TOWN OF WATERBURY EXHIBIT **A1**

ZONING PERMIT APPLICATION

Brief description of project: Revisions to the previously approved 9-lot PUD approved under 082-20,
including removing Lot 3, revising access to Lot 7, adding a dwelling unit
on Lot 2, and miscellaneous property line/acreage changes.

<p>REVISION 12/12/2020 REVISED LAYOUT</p>	
<p>OVERVIEW HONEYSUCKLE HILL NINE LOT SUBDIVISION JOHN MUTCHLER & PERRIN WILLIAMS</p>	
<p>SWEET & RIPLEY ROADS WATERBURY, VT</p>	
<p>SCALE : 1" = 200' DESIGNED BY: GNM PROJECT #25130D DRAWN BY: WDB CHECKED BY: GNM</p>	<p>MCCAIN CONSULTING, INC. 93 SOUTH MAIN STREET WATERBURY, VERMONT 05676</p>
<p>DATE: JULY 22, 2020</p>	<p>SHEET C-1</p>

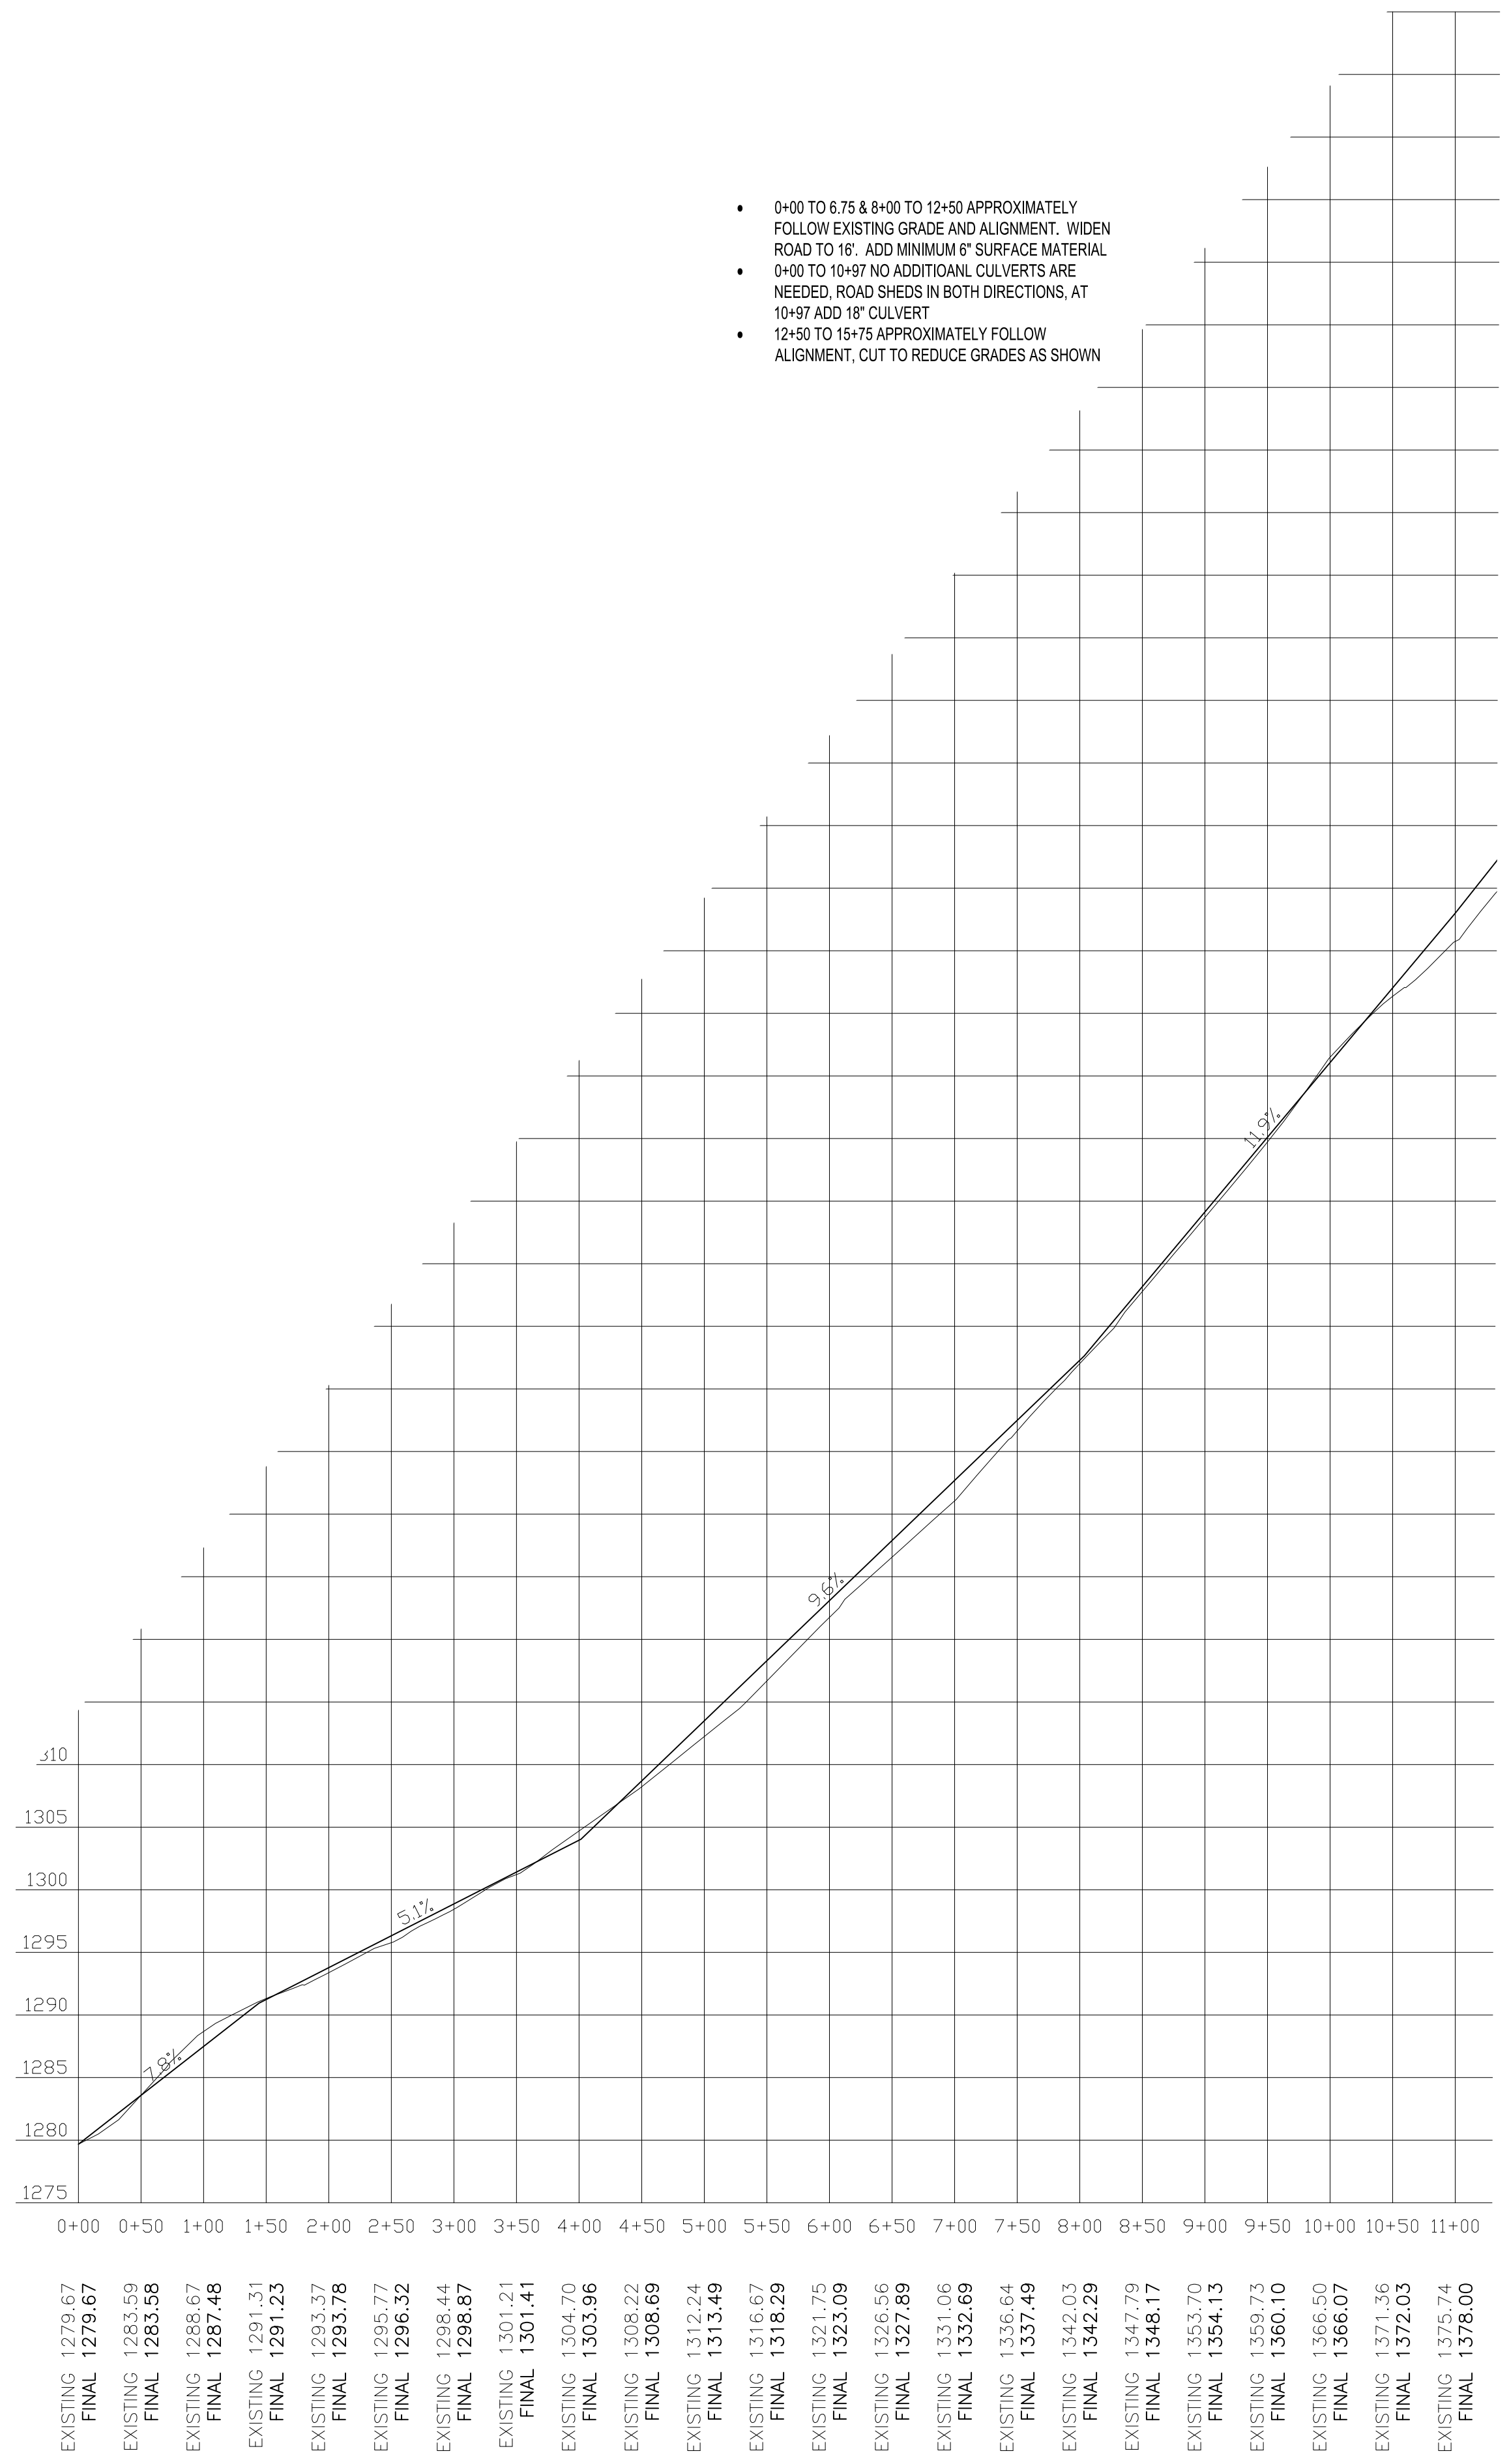
REVISION 12/14/2020 REVISED DRIVEWAY LAYOUT FOR LOT 7	
ACCESS PLAN HONEYSUCKLE HILL NINE LOT SUBDIVISION JOHN MUTCHLER & PERRIN WILLIAMS SWEET & RIPLEY ROADS WATERBURY, VT	
SCALE : AS NOTED DESIGNED BY: GNM PROJECT #25130D DRAWN BY: WDB CHECKED BY: GNM	MCCAIN CONSULTING, INC. 93 SOUTH MAIN STREET WATERBURY, VERMONT 05676
DATE: JULY 22, 2020	SHEET C-11B

PRE-DEVELOPMENT CLEARING PLAN
HONEYSUCKLE HILL
 NINE LOT SUBDIVISION
 JOHN MUTCHLER & PERRIN WILLIAMS
 SWEET & RIPLEY ROADS WATERBURY, VT

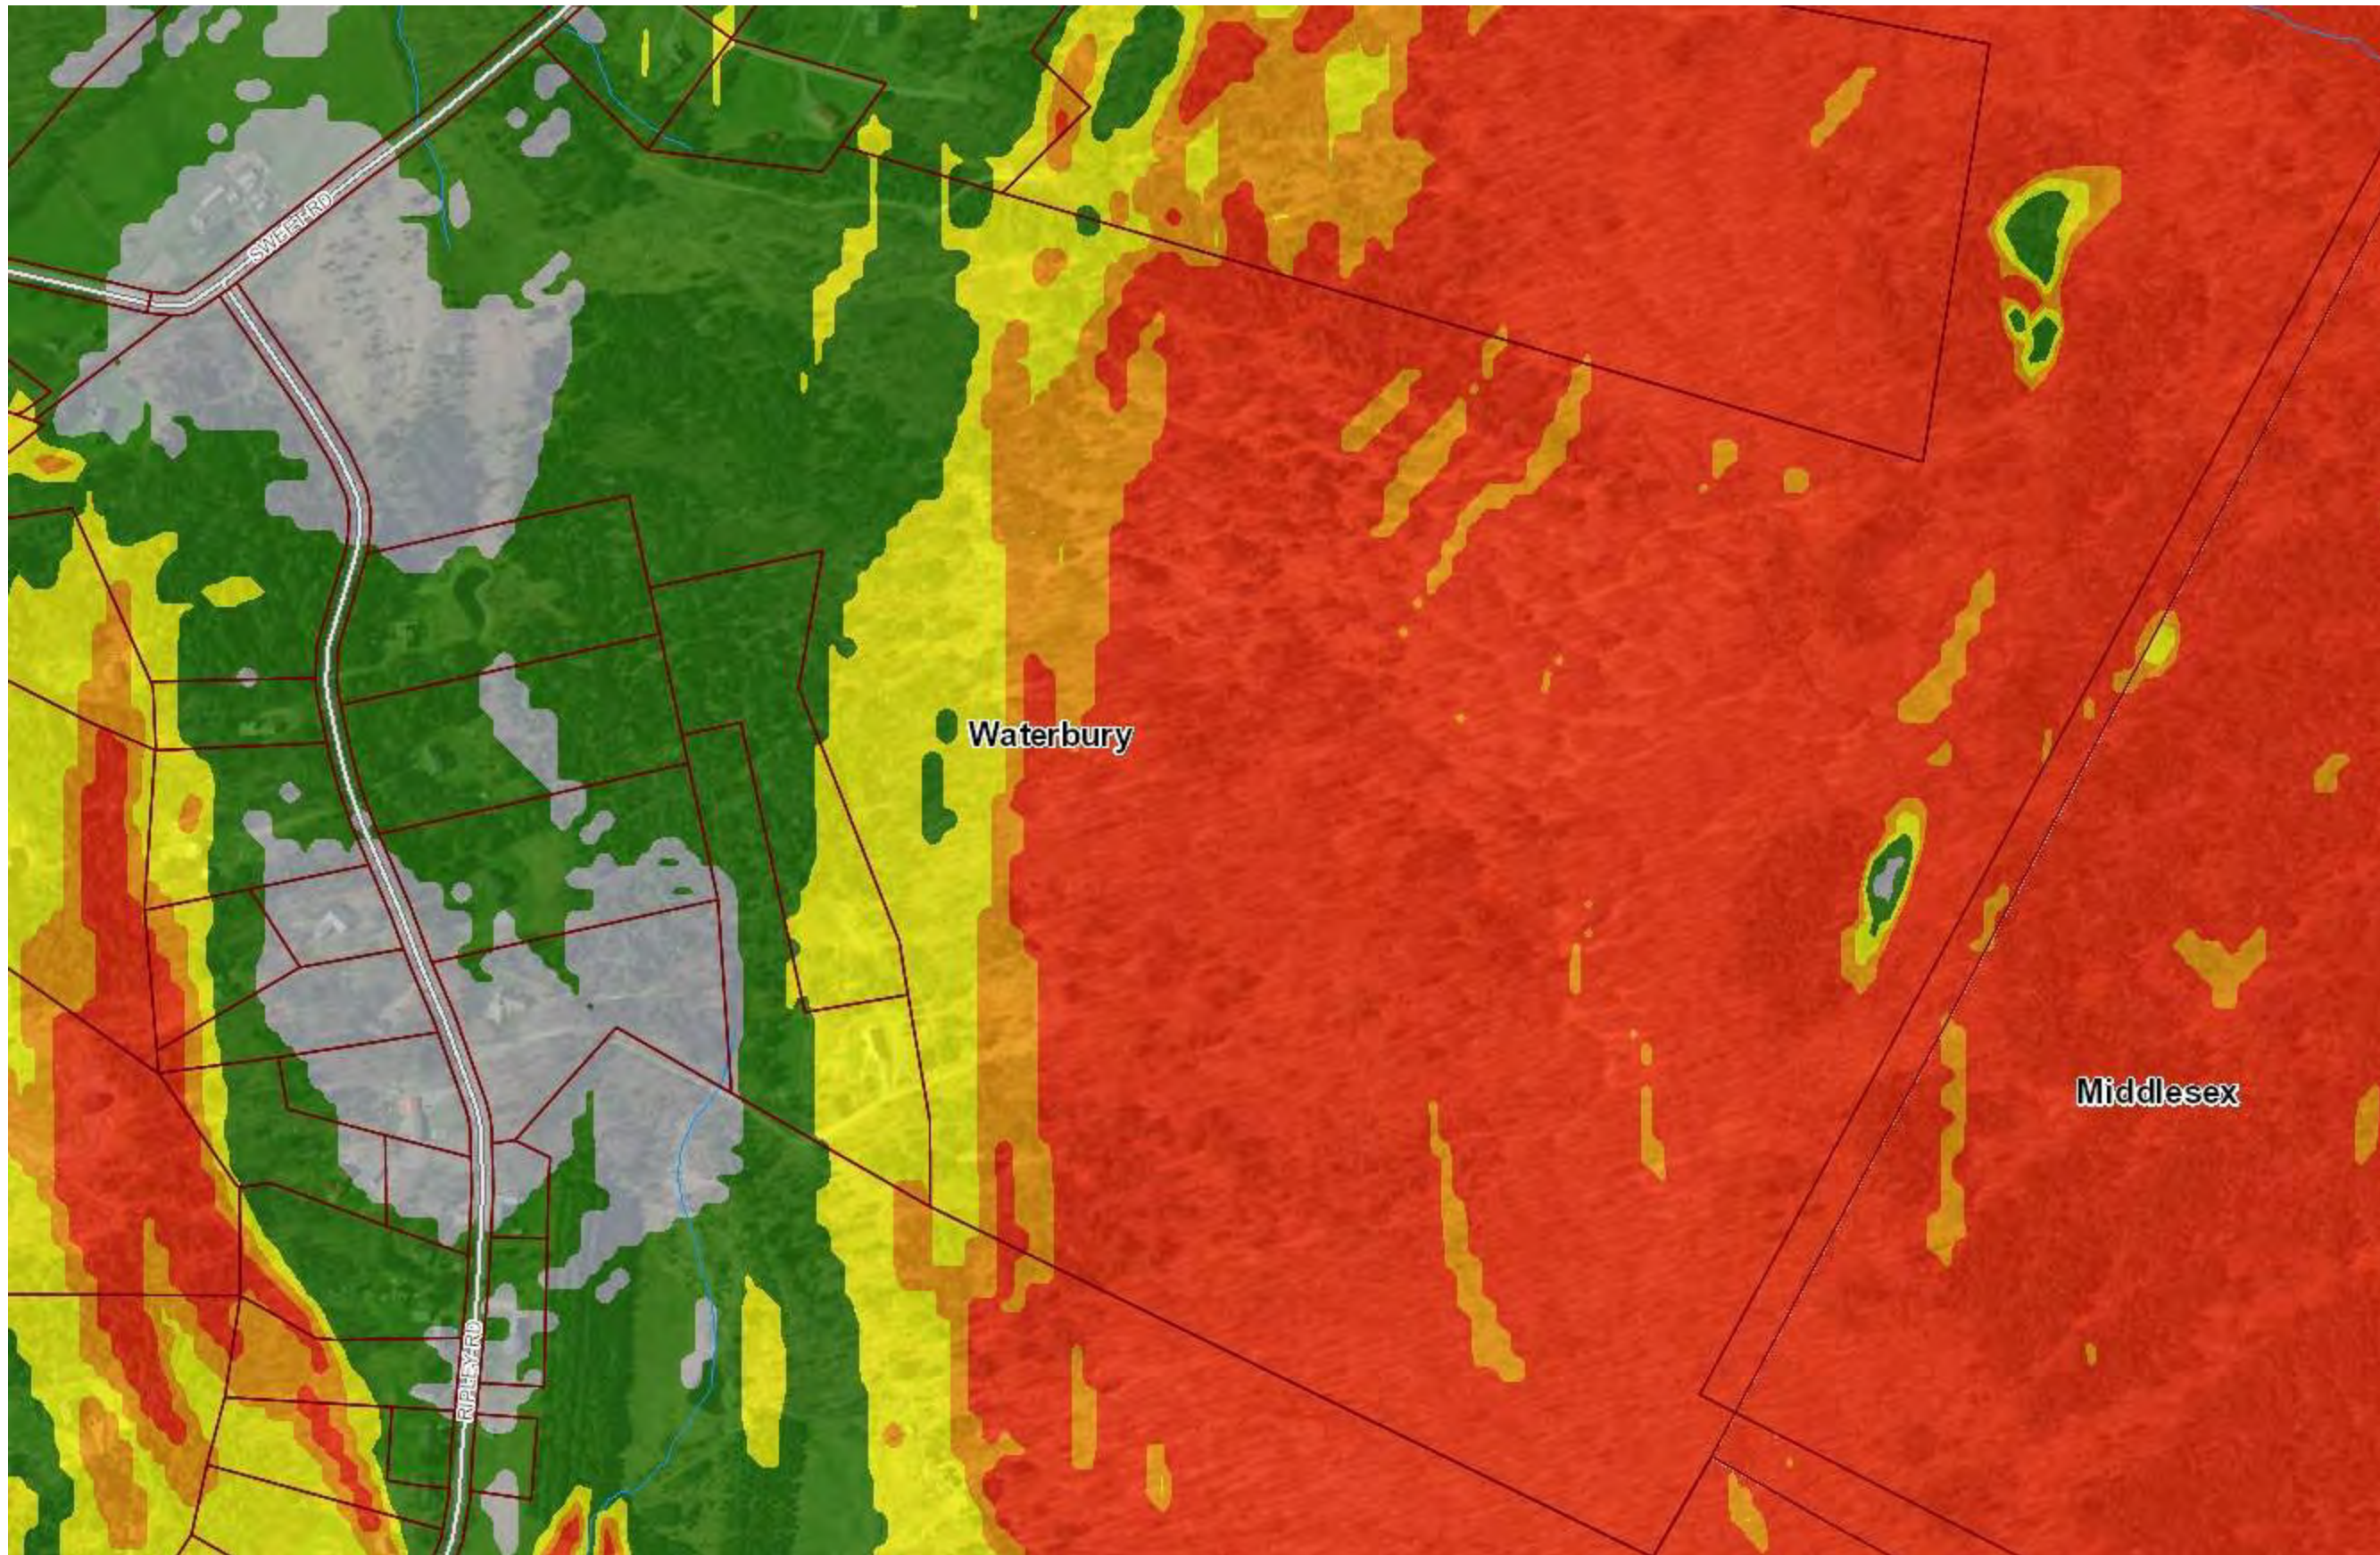
Pre-development clearing – SEE UPDATED PRE-DEVELOPMENT CLEARING PLAN

In addition to the requested approval for this subdivision, the application also requests approval of the pre-construction clearing plan included with the application materials. That request is for cutting along the edges of the roads for maintenance and to perform the required improvements, cutting of the leachfields and stormwater pond areas, and limited cutting (max 35% of the trees) for the building envelopes and areas below to begin to open up views.
